HISTORIC AND DESIGN REVIEW COMMISSION

May 4, 2022

HDRC CASE NO: 2022-240
ADDRESS: 114 DEWBERRY ST
LEGAL DESCRIPTION: NCB 6461 (MISTLETOE ADDITION SUBDIVISION), BLOCK 1 LOT 57
ZONING: R-4, H
CITY COUNCIL DIST.: 1
HIST. DIST. NAME: River Road
APPLICANT: David Pina/Grand Builders LLC
OWNER: PINA DANIEL & STEPHANIE
TYPE OF WORK: Construction of a two-story residence
APPLICATION RECEIVED: April 22, 2022
60-DAY REVIEW: Not applicable due to City Council Emergency Orders
CASE MANAGER: Jessica Anderson

The applicant is requesting conceptual approval to construct a two-story residential structure on the vacant lot at 114 Dewberry.

FRONT ELEVATION

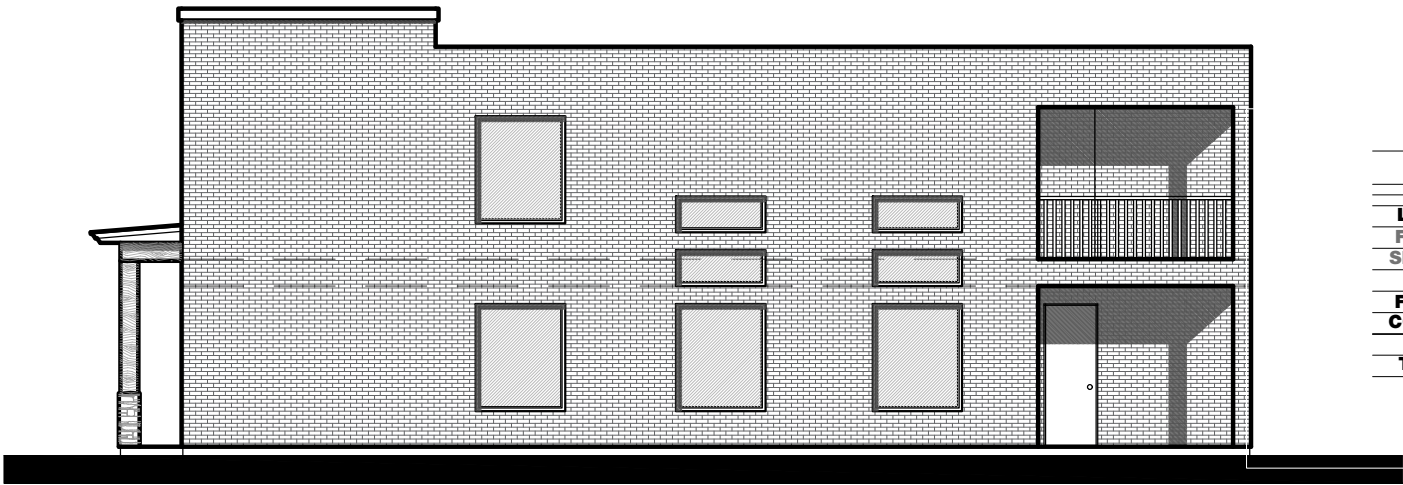
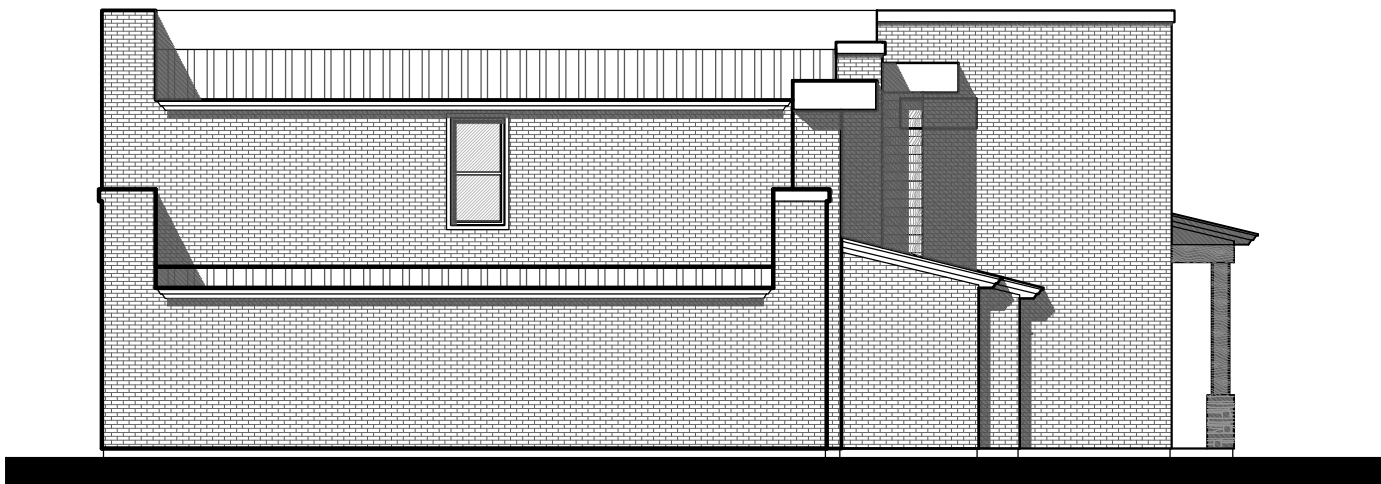
- d. **ENTRANCES** – According the Guidelines for New Construction 1.B.i. primary building entrances should be orientated towards the primary street. The proposed entrance orientation is appropriate and consistent with the Guidelines; however, staff finds that the proposed entrance massing and detailing is not consistent with the Guidelines. Entrance massing should feature traditional forms and details, as found historically within the district.

- e. **SCALE & MASS** – Per the Guidelines for New Construction 2.A.i., a height and massing similar to historic structures in the vicinity of the proposed new construction should be used. In residential districts, the height and scale of new construction should not exceed that of the majority of historic buildings by more than one-story. Though there are no other street-facing structures on the block, as noted in finding b, River Road predominately features one-story and one-and-a-half-story residences, with a handful of examples of two full stories. The applicant has proposed a massing and scale that is not consistent with the massing and scale of historic residential structures found within the River Road historic district, specifically with regard to architectural form. Staff finds that massing and scale that is consistent with the Guidelines for New Construction should be incorporated into the design. A two-story structure may be appropriate provided architectural forms are consistent with the Guidelines and historic two-story structures found within the district.

proposed new construction should align with other structures in the historic district. Nearby historic structures on this block feature foundation heights of between one and three feet. The applicant has proposed a foundation on grade. Staff finds the proposed foundation height should be increased to at least one foot in height.

- g. **ROOF FORM** – The applicant has proposed flat roof forms. This is not consistent with the Guidelines for New Construction, as the Guidelines note that roof forms for new construction should be comparable with those found historically within the district. Historic residential structures within the River Road historic district feature gabled and hipped roofs.

- i. **MATERIALS** – The applicant has proposed a structure clad in brick with stone piers and wood posts on the front porch. The applicant did not submit specs for windows, doors, or garage doors. Brick cladding is not typically found in the River Road historic district; houses are predominately stucco- or wood-clad. Staff finds the use of brick to be inappropriate.

- k. **FENESTRATION PROFILE** – The applicant has proposed fenestration profiles that feature both window profiles and locations that are inconsistent with the Guidelines and historic fenestration profiles found throughout the district. Staff finds that the proposed fenestration profiles should be amended to be consistent with the Guidelines. Additionally, staff finds that additional fenestration should be added throughout, specifically in locations void of fenestration. Windows should feature traditional sizes and a one-over-one profile. Contemporarily sized windows and fixed windows should be eliminated from the proposed new construction.

- m. **ARCHITECTURAL DETAILS (Porches)** – Historic structures within the River Road historic district feature front porches that are a prominent architectural feature of the structure. Historically, porches feature their own massing and roof form. The applicant has proposed an entrance that is not within the context of a traditionally sized porch. Staff finds that the proposed entrance element should be amended to feature traditional porch massing.

- n. **ARCHITECTURAL DETAILS (Garages)** – The applicant has proposed for the structure to feature one street-facing garage door on the front, street facing façade of the new construction. Attached garages located on the front façade of houses is not found historically within the district and is inconsistent with the Guidelines. Staff finds that the proposed garage should be eliminated and that parking should be located elsewhere on the site.

- i. That the applicant incorporate entrance massing and elements that are consistent with the Guidelines and historic examples found throughout the district, as noted in finding d.

- ii. That the applicant incorporate proposed massing and scale consistent with the Guidelines for New Construction, as noted in finding e.
- iii. That the applicant incorporate a roof form that is consistent with the Guidelines and historic examples found throughout the district, as noted in finding g.

- iv. That the applicant incorporate materials and material profiles that are found historically within the district, as noted in finding i.
- v. That the applicant incorporate a foundation height that is consistent with the Guidelines, as noted in finding f.

- vii. That the applicant amend the proposed fenestration profile and incorporate additional window openings through the proposed new construction, as noted in finding k. Proposed windows should feature a one over one profile.

- viii. That the proposed front loading garage be eliminated and that parking should be located elsewhere on site, as noted in finding n.
- ix. That a front walkway constructed of materials consistent with other walkways in the district be installed, as noted in finding o.

SITE PLAN

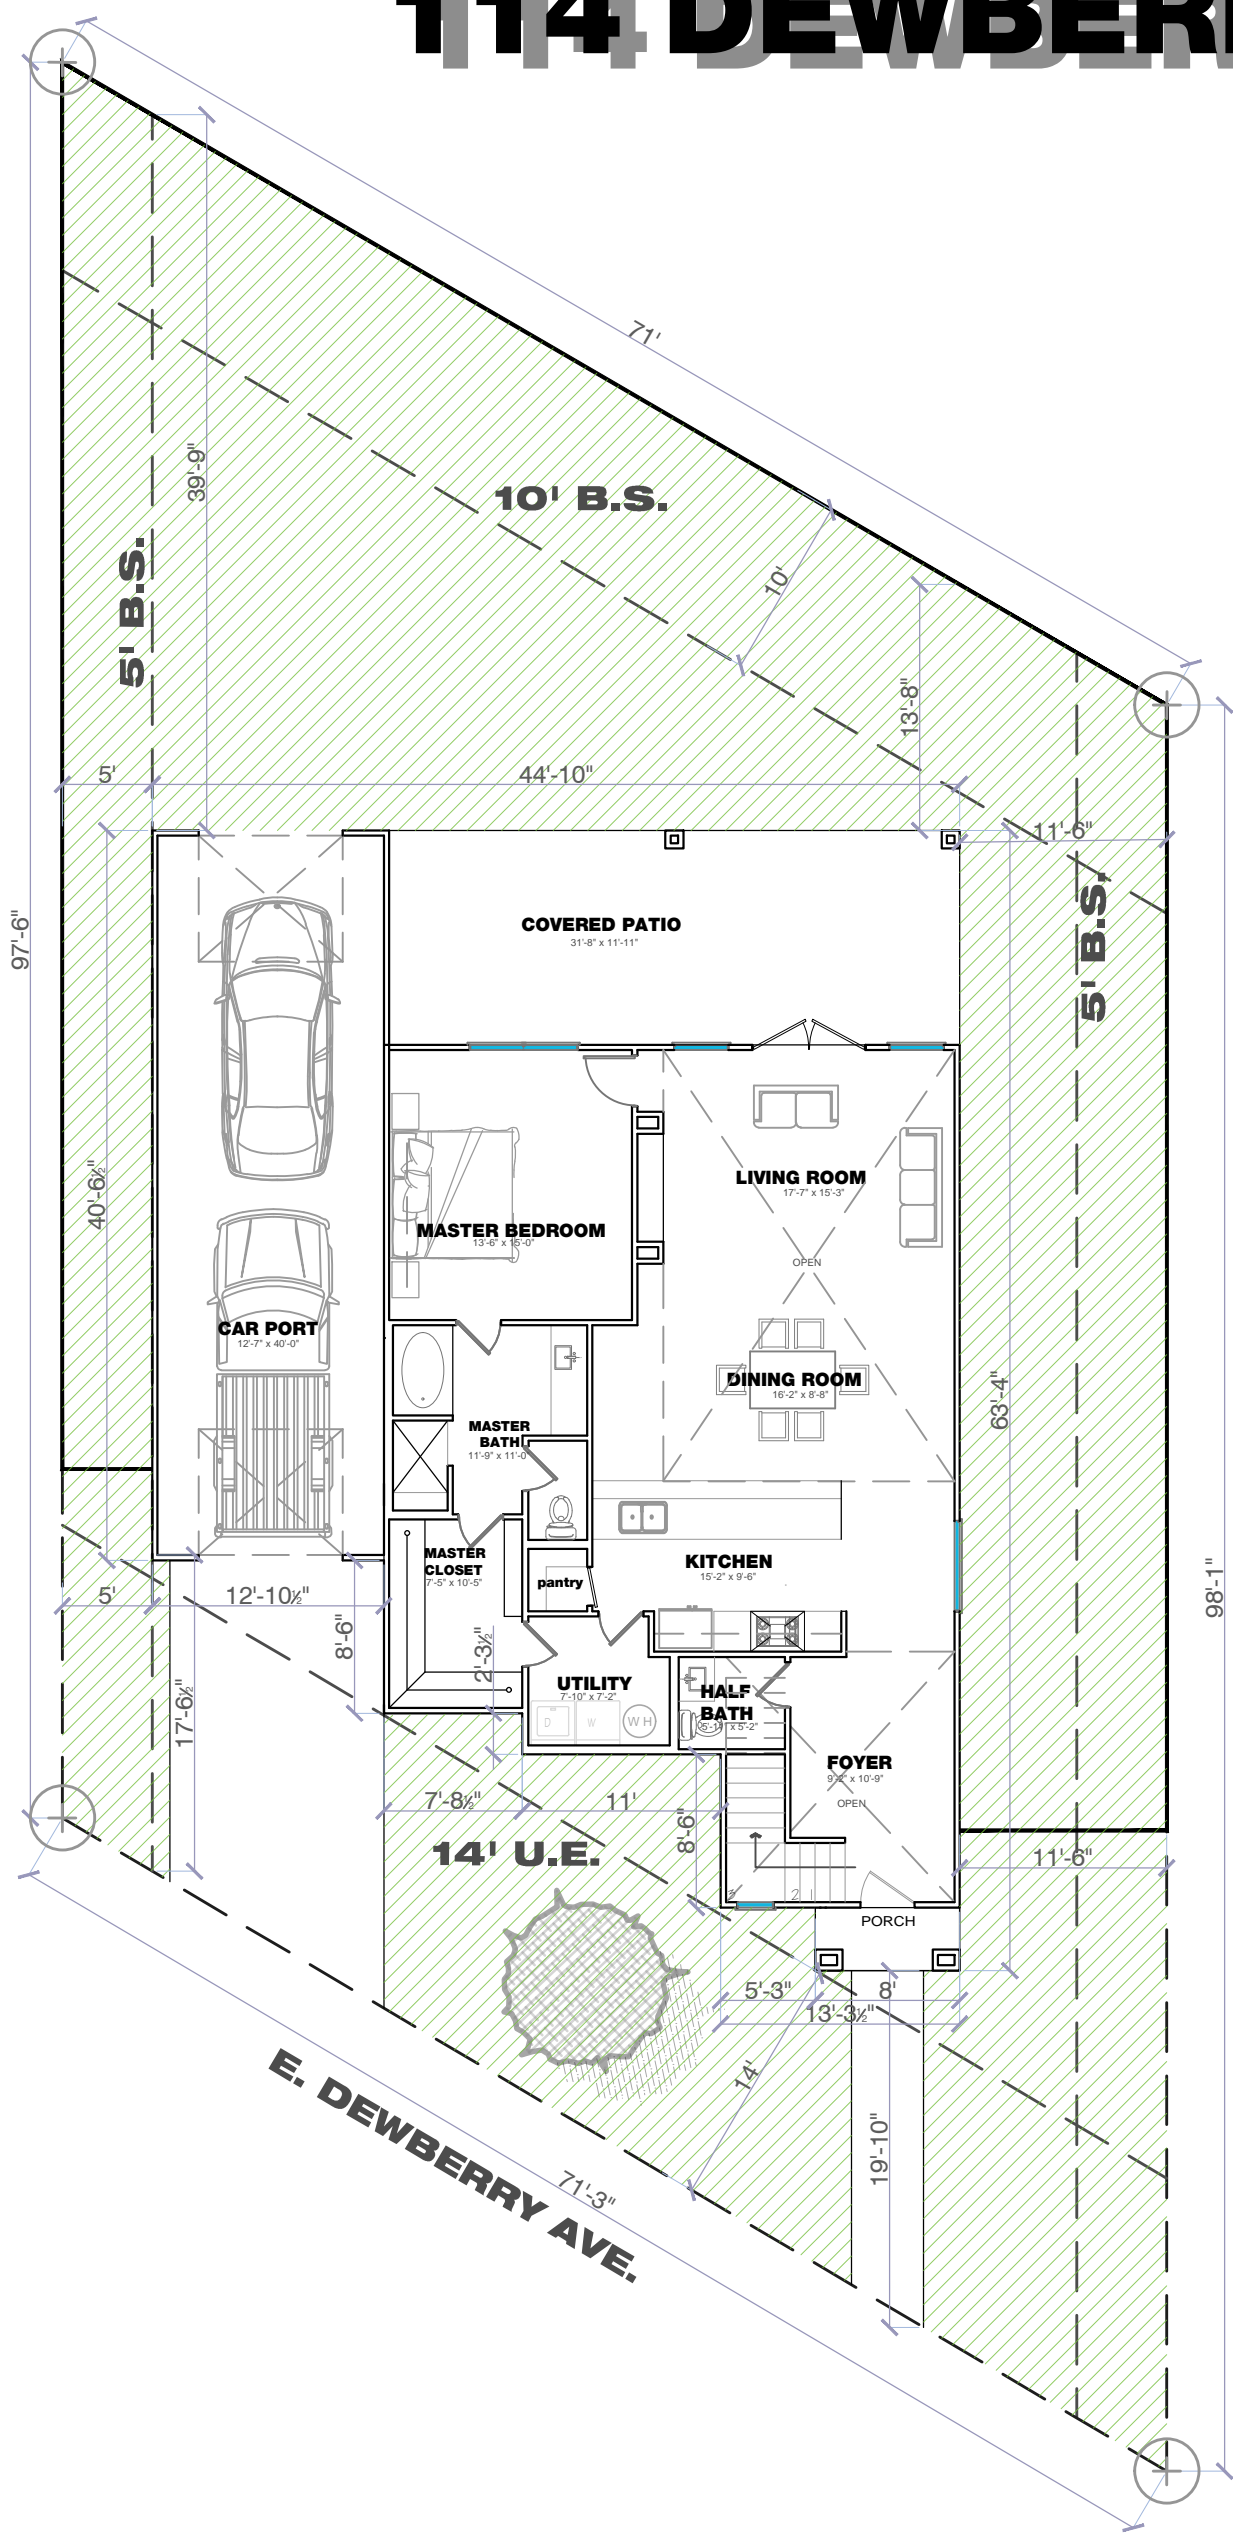
- c. **SETBACKS & ORIENTATION** – According to the Guidelines for New Construction, the front facades of new buildings are to align with front facades of adjacent buildings where a consistent setback has been established along the street frontage. Additionally, the orientation of new construction should be consistent with the historic examples found on the block. The applicant has proposed a setback of approximately 14 feet from the property line. Though there are no other street-facing structures on this block, the rest of the River Road historic district features setbacks roughly 11 to 20 feet from the right-of-way. Staff finds that the proposed setback for this new construction features a setback that is equal to or greater than those found historically on the block, and thus conforms to guidelines. A greater setback would be most appropriate for a two-story structure.

- h. **LOT COVERAGE** – Per the Guidelines, the building footprint for new construction should be no more than fifty (50) percent of the size of the total lot area. The proposed residence has 2,030 square feet of living space with an attached 524-square-foot garage, bringing the total footprint to 2,554 square feet. This does not include a covered porch at the rear of the property, which would bring the total square footage to 2,931. The lot is 6,011 square feet. Staff finds the lot coverage consistent with the Guidelines.

- o. **WALKWAY** – The applicant has proposed a single front walkway that meets the front porch and door. The applicant did not submit walkway materials for conceptual approval. Historic walkways within the district feature solid, poured concrete profiles. Staff finds the proposed walkway dimensions are consistent with the Guidelines and that a walkway constructed of materials consistent with other walkways in the district be installed.

- q. **DRIVEWAYS** – The applicant has proposed one driveway that is 12 feet 10.5 inches wide, which exceeds the recommended width of 10 feet. Staff finds the proposed driveway configuration to be inappropriate and inconsistent with the Guidelines. Staff finds that a driveway featuring a width of no more than 10 feet should be proposed.

- x. That a detailed landscaping plan be submitted for review that adheres to the Guidelines for Site Elements, as noted in finding p.
- xi. That a driveway be proposed that features a profile and width that is consistent with the Guidelines, not to exceed 10 feet in width, as noted in finding q.
